APPLICABILITY: 2018-21MY Crosstrek
 2017-23MY Impreza
 2020-23MY Legacy & Outback

SUBJECT: Cowl Panel – Design Change

NUMBER: 12-321-21R
DATE: 07/19/21
REVISED: 03/26/24

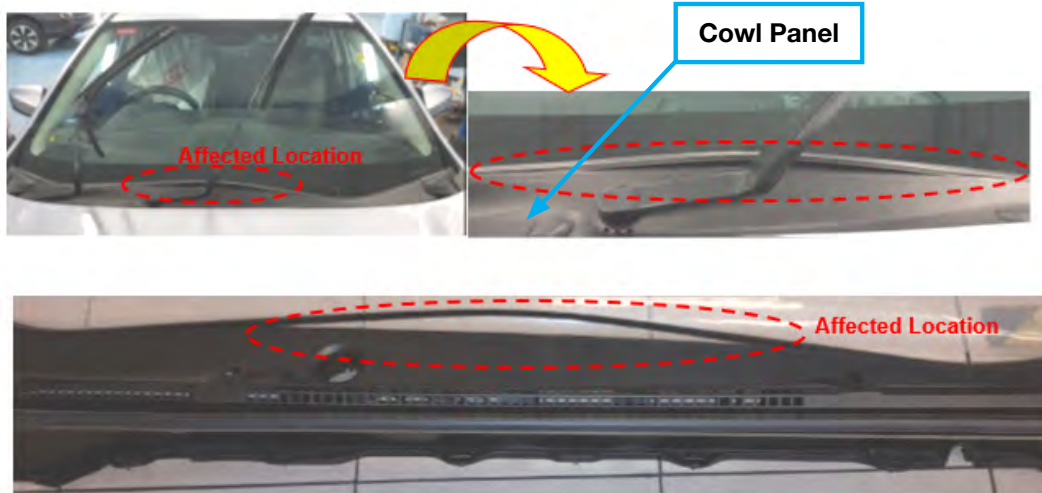
This bulletin announces a design change made to the cowl panel. These new parts utilize ten additional fixing points between the cowl panel and its rubber protector. This change was made to address a small number of cases where the rubber sealing portion had become separated as shown below. If this issue is confirmed, the cowl panel must be replaced.

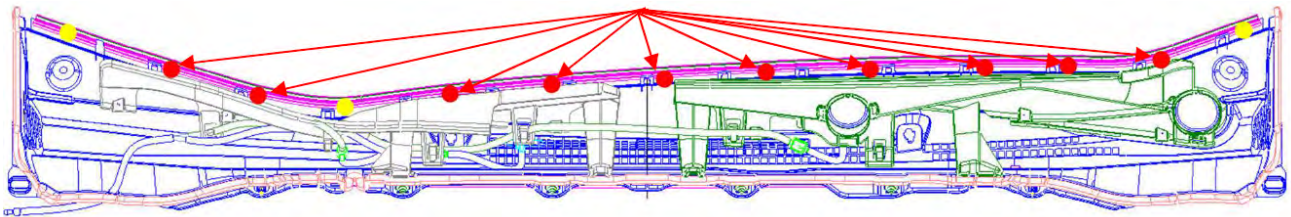
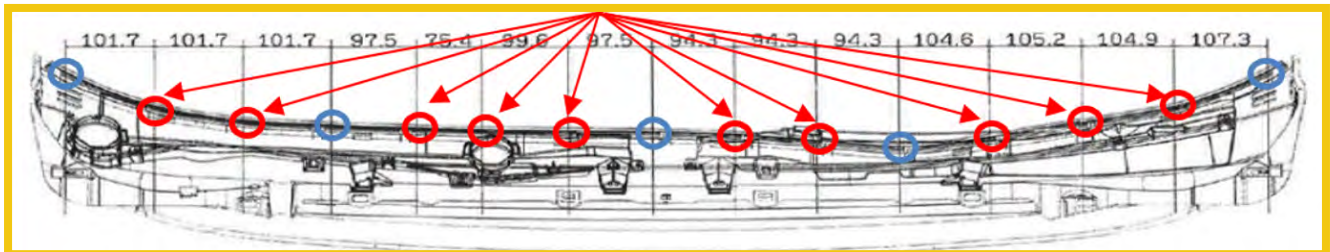
10 additional fixing points have been incorporated into the new cowl panel.
